AMENDMENT UNDER 37 C.F.R. § 1.116
U.S. Appln. No. 10/663,685
Attorney Docket No.: Q77511

AMENDMENTS TO THE DRAWINGS

FIG.1

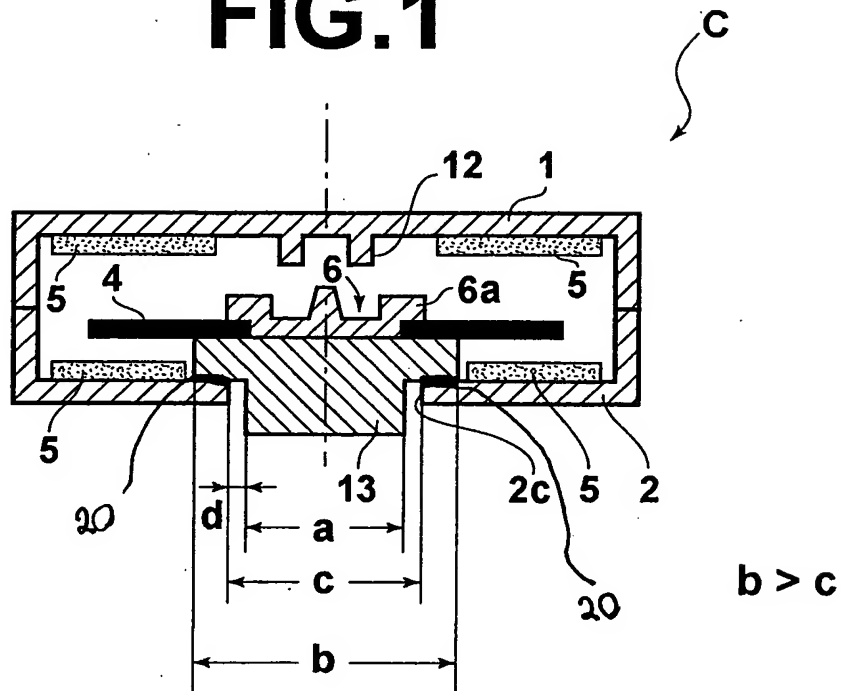
Figure 1 is amended to illustrate an exemplary member with a sliding property.

The Examiner, however, issued new objections to the drawings. Specifically, the Examiner requests that the member set forth in claims 13 and 15 be depicted in the Figures. Applicant amends Fig. 1 to illustrate the claimed member. Applicant also amends the specification to describe the newly added element. In view of these amendments, Applicant respectfully requests the Examiner to withdraw this objection to the drawings.
